**Landscape Review Committee**  
**Hybrid In-Person & ZOOM Online Meeting**  
**Wednesday, February 7, 2024 - 12:00 PM**

## **EXHIBIT 2 - STAFF REPORT**

**DATE:** February 7, 2024  
**TO:** Landscape Review Committee Members  
**FROM:** Tom Schauer, Senior Planner  
**SUBJECT:** Landscape Plan Review Application (L 53-23)

**DOCKET:** L 53-23 (Landscape Plan Review)

Figure 3a. Applicant's Proposed Site Plan

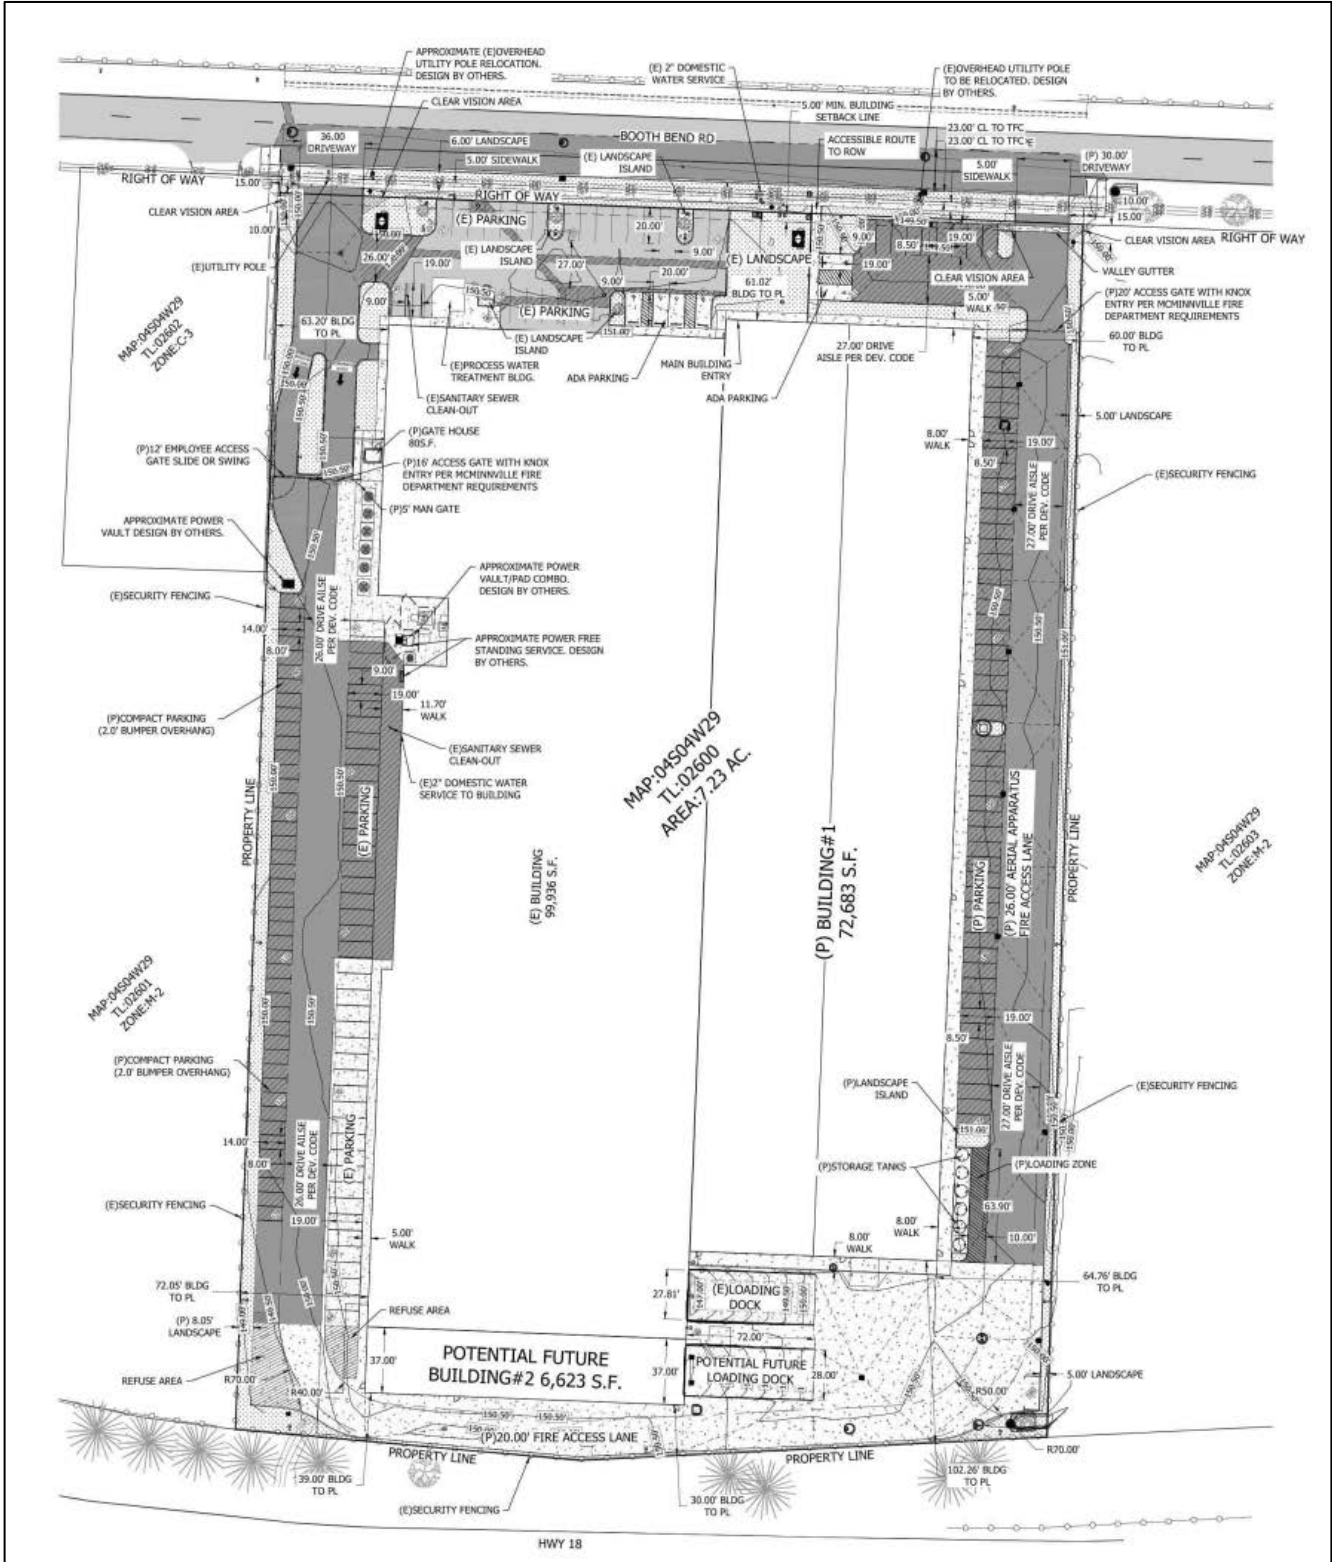
The applicant has indicated a refuse area near the south west corner of the site (cross-hatched area shown on landscape plan). ***A solid waste enclosure will be required for the refuse area. Will the enclosure be visible from the street? Does the proposed landscaping at the southwest corner of the site satisfy these standards, or is a condition/revision required?***

Compact parking spaces are shown along the southerly portion of the west side of the site. The landscape plan shows spaces that measure 14 feet long rather than the 16 foot length specified in the Zoning Ordinance, with 8 feet of planting area between the spaces on the west property line. Approximately 2 feet of the landscape area is shown to be free of shrubs which would allow for vehicle overhang over the landscape area. This appears to increase the planting area by over 700 square feet. The plan doesn't identify groundcover for the "overhang" area. Curbing is proposed between the edge of pavement and landscape area.

- b. The site plan and landscape plan shall be updated to show the required solid waste enclosure. The building permit submittal shall demonstrate compliance with the required construction materials and design standards.

### Figure 3b. Landscape Plan

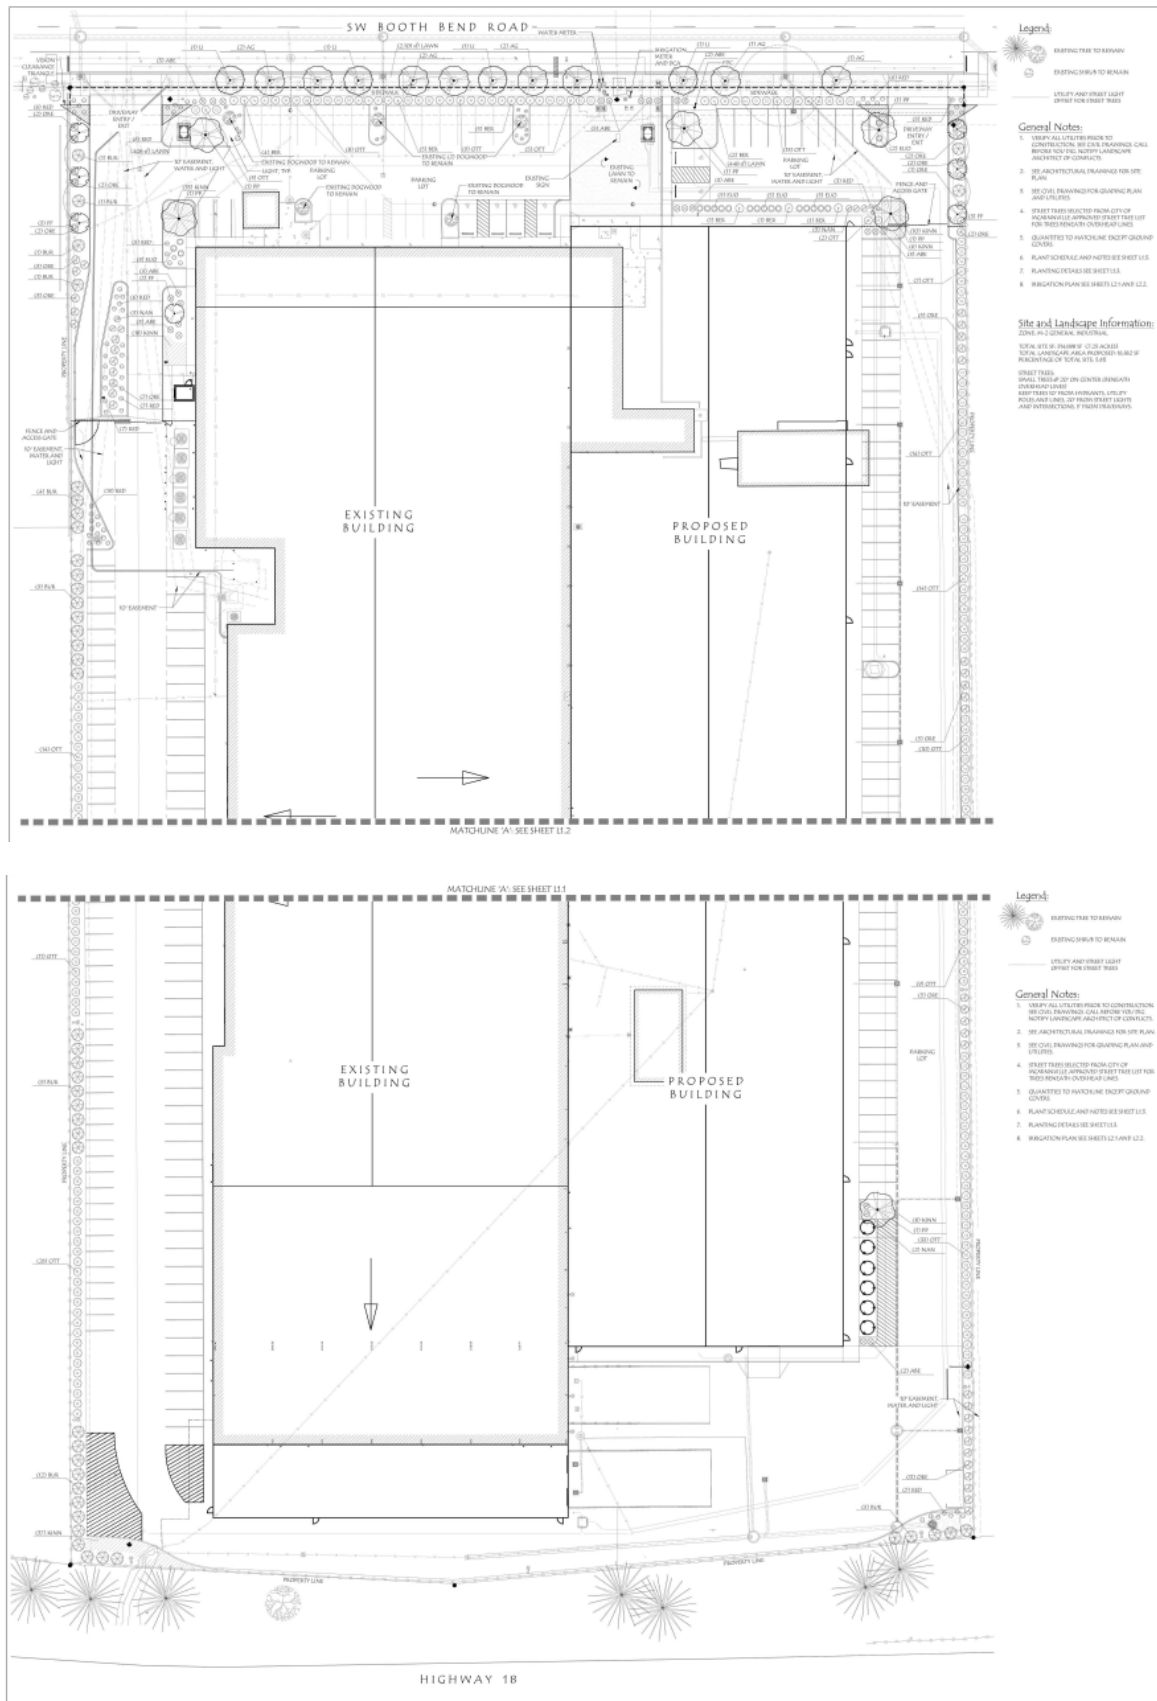
It is therefore evident that the rear, gated portions of the site do not have the parking aisles broken up with landscape islands to the same extent present in the parking areas at the ungated front portion of the site, maximizing area for required parking along the sides of the building on the rear portion of the lot. Instead, the rear areas predominantly have perimeter landscape screening, with shrub plantings along the east and west property lines. Within the gated area, one tree is proposed in the landscape area at the south side of the parking aisle on the east side of the new building.

2. The proposed plan shows a planter strip with irrigated turf and street trees. That area has overhead power with both communications (lower) and primary power (higher).

- a. It is recommended that the proposed street trees be revised to specify a more columnar tree selected from the street tree list of small trees suitable for planting under utilities, in order to minimize adverse impact on the trees associated with the pruning and clearance requirements for street trees along Major Collector streets.

- d. The landscape plan shall reflect any revisions by the Landscape Review Committee found necessary to satisfy the applicable landscaping and street tree factors, criteria, and standards of the Zoning Ordinance.
  - e. Identify any proposed exterior lighting and method of shielding/downcast lighting. (Details may be included on civil sheets) or separate submittals).
2. Ensure provisions of sleeving for irrigation to all irrigated planting areas.
3. Once approved, the applicant shall install landscaping as shown on the revised and approved landscape plans addressing the items above. Landscaping shall be installed prior to final inspection for the building permit, or the applicant shall provide financial surety equal to 120% of the installed landscaping cost as specified in the Zoning Ordinance, and landscaping shall be completed no later than 6 month from final inspection.

Sheet C105

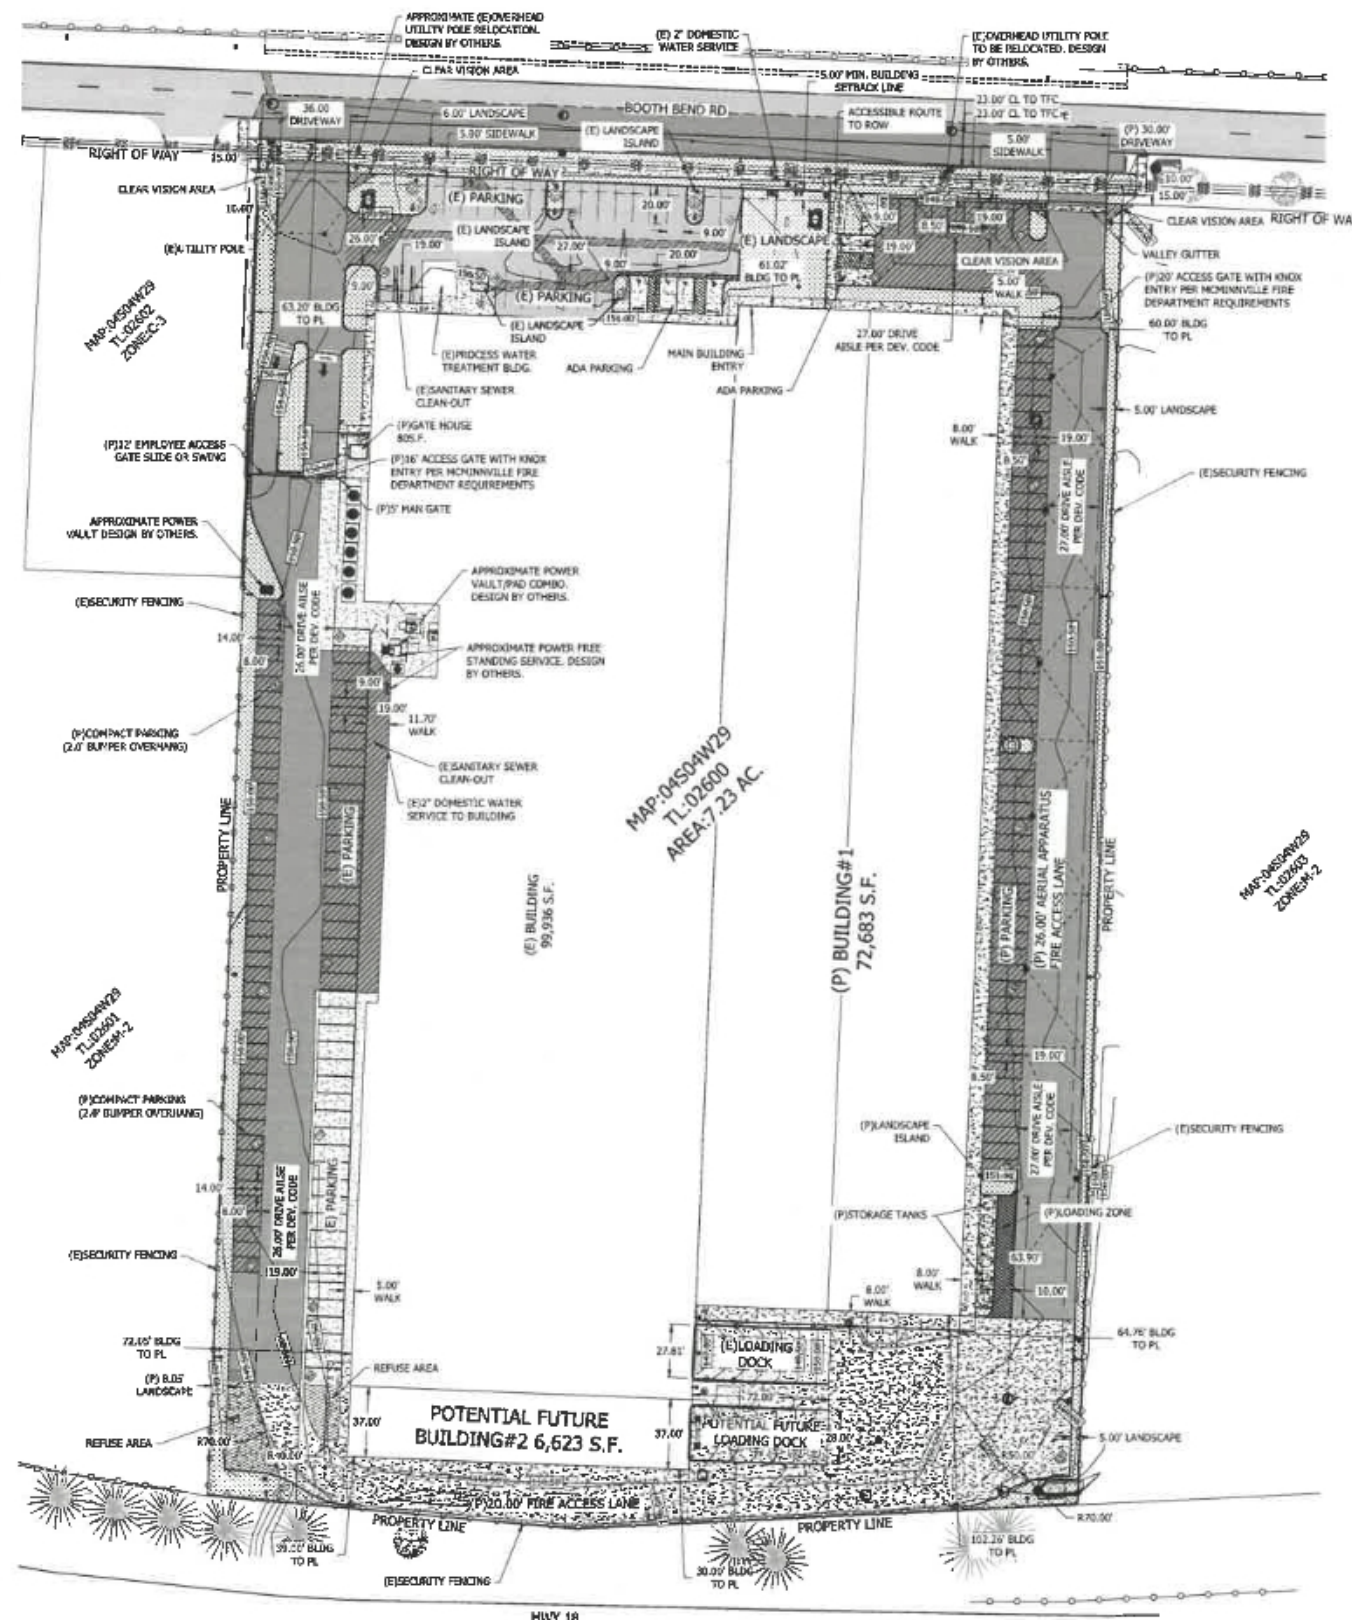
It is contested that on-site parking calculations are reviewed in association with the building permit as opposed to the landscape plan review application. However, notably Sheet C105 – Site Plan illustrates the location of proposed parking stalls and lists parking computations in text format on this same sheet.

Based on the above calculations the greater of the two vehicle parking standards is vehicle parking spaces per floor area, which equates to a minimum of 180 required vehicle parking spaces. As noted above, Sheet C105 – Site Plan illustrates the location of the proposed 180 vehicle parking stalls, which meets the minimum standard based on proposed floor area.
